RESPONSE TO CEC STAFF DATA REQUEST SET 3 (46-56)

Gilroy Backup Generating Facility (20-SPPE-03)

SUBMITTED TO: CALIFORNIA ENERGY COMMISSION
SUBMITTED BY: **Amazon Data Services, Inc.**

September 22, 2021

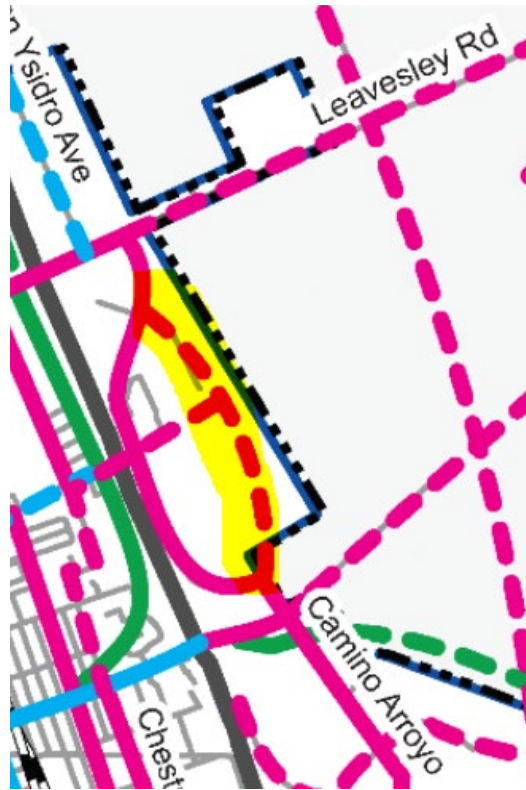
53. Please provide confirmation from the City of Gilroy whether the project applicant would be required to construct a bicycle facility through the project site or another alternative. If construction of a bicycle facility is required, please provide details describing and illustrating the location, the necessary construction activities required by the City, and the estimated duration of construction.

In terms of conflicts with the General Plan policies, the future bicycle path (dashed line) is classified as Class II bicycle path which would be striped on a future roadway. The future roadway was probably envisioned to allow the property to be developed into uses satisfying the General Plan General Industrial designation so that multiple industrial facilities could gain access to their respective properties. Such access is no longer needed to develop the property as the GDC would encompass all of the land. The future bicycle path running through the site would connect two points that are already connected by an existing bicycle path (solid line). The future bicycle path would not shorten trip lengths between those two points and would not provide meaningful access to anything other than privately-owned land, so eliminating this future bicycle path would not affect connectivity in the area and, therefore, would not conflict with General Plan policies intended to increase bicycle path connectivity and bicycle usage.

As discussed above the future proposed Class II bicycle path was to be striped on a future roadway. Attachment TRANS DR-53 includes a memorandum from the City of Gilroy describing its concurrence that elimination of the future roadway would not interfere with the connectivity envisioned by its planning efforts. ADS believes that for the reasons above, the City of Gilroy would concur that a similar finding is applicable to the proposed future bicycle path.

SHEET TITLE: PRELIMINARY FIRE DEPARTMENT WATER SUPPLY PLAN

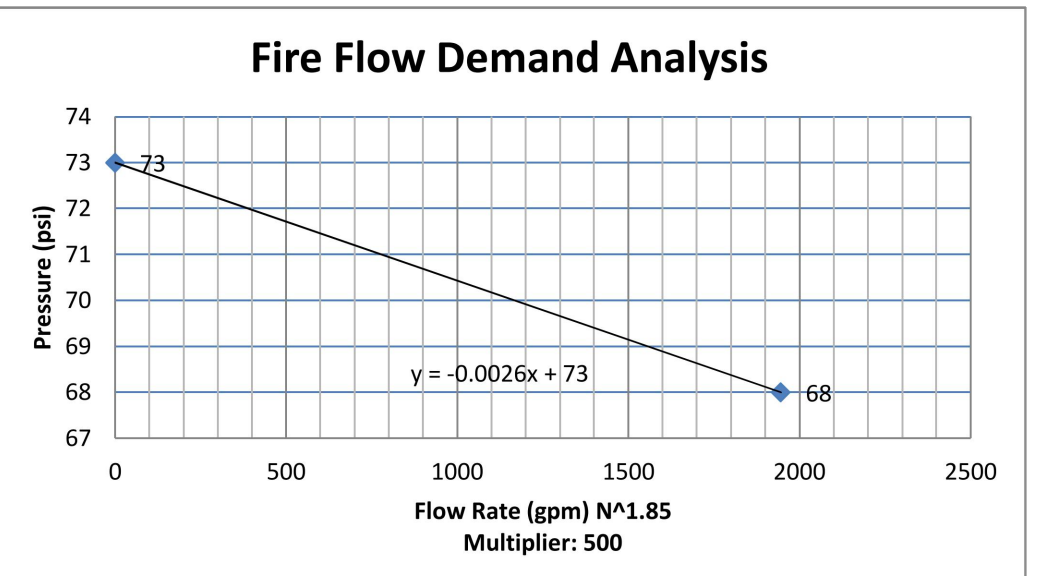
52. Please describe and locate a water supply and any fire hydrants near the lithium-ion BESS enclosures.

At this time, ADS believes that it has designed a fire loop system that will be sufficient to respond to a fire at either the data center or at the BESS. Please see Attachment HAZ DR-52 for the preliminary fire water supply plan. During final design and as ensured by PD HAZ-2 the City of Gilroy will review, comment and ultimately approve the fire water supply and hydrant locations for the site.
